BROWNS FERRY NUCLEAR PLANT, UNIT 1

AMENDMENT TO FACILITY OPERATING LICENSE

Amendment No. 91  
License No. DPR-33

ATTACHMENT TO LICENSE AMENDMENT NO. 91

Figure 3.5.K-1

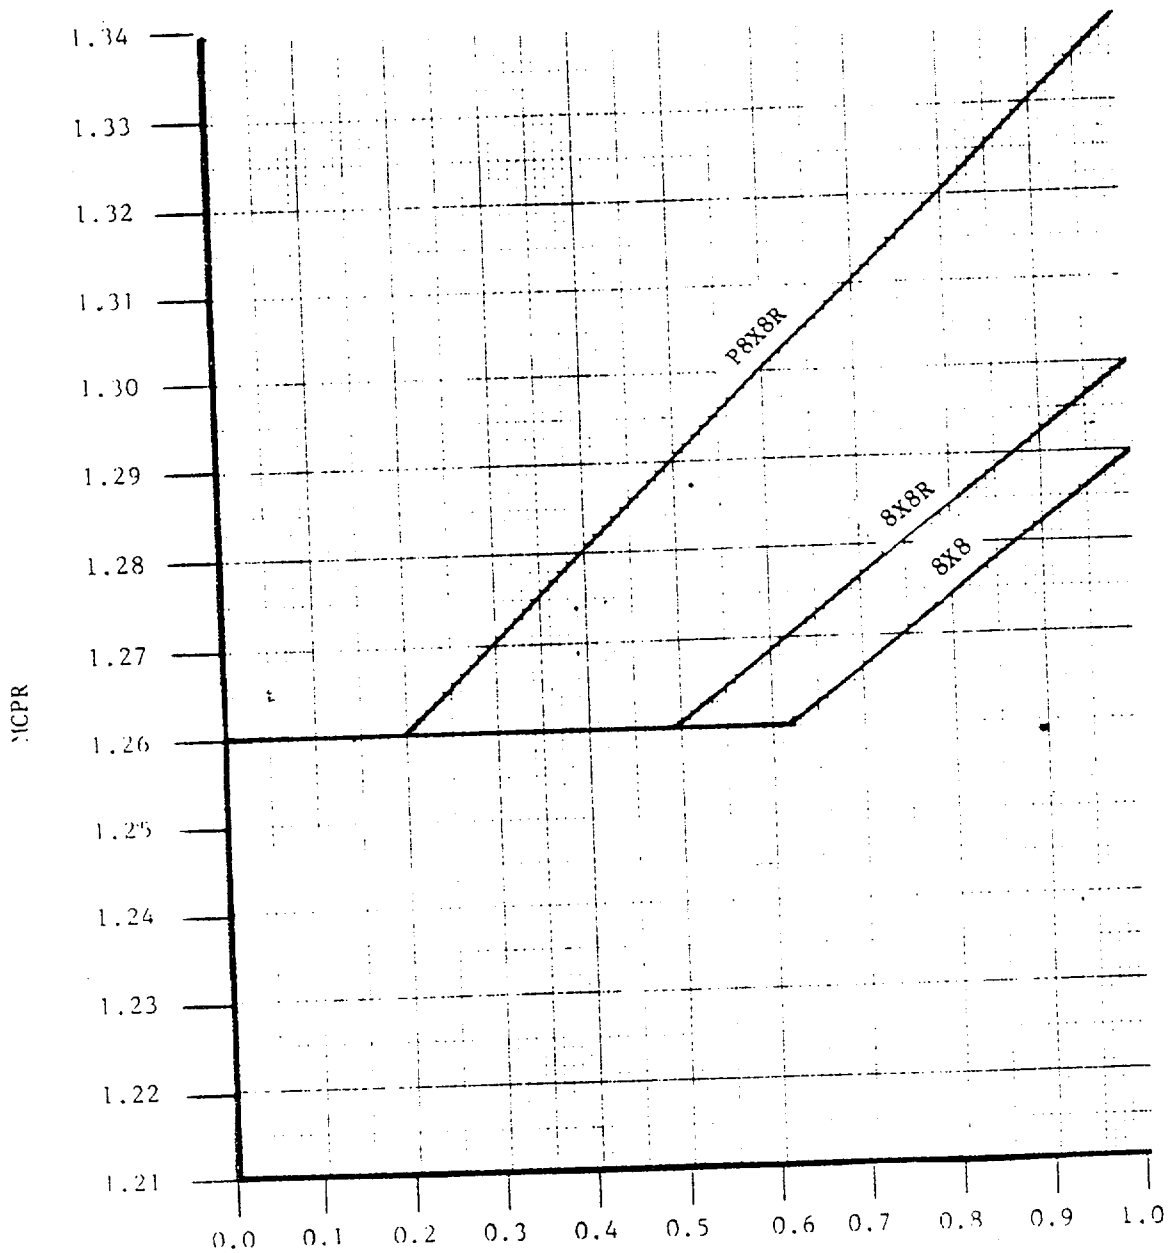
The operating limit MCPR values are being altered to conform to the results of the safety analysis for Cycle 6 and are acceptable. Additional MAPLHGR curves for the new fuel being inserted for this cycle are included. These are acceptable changes.
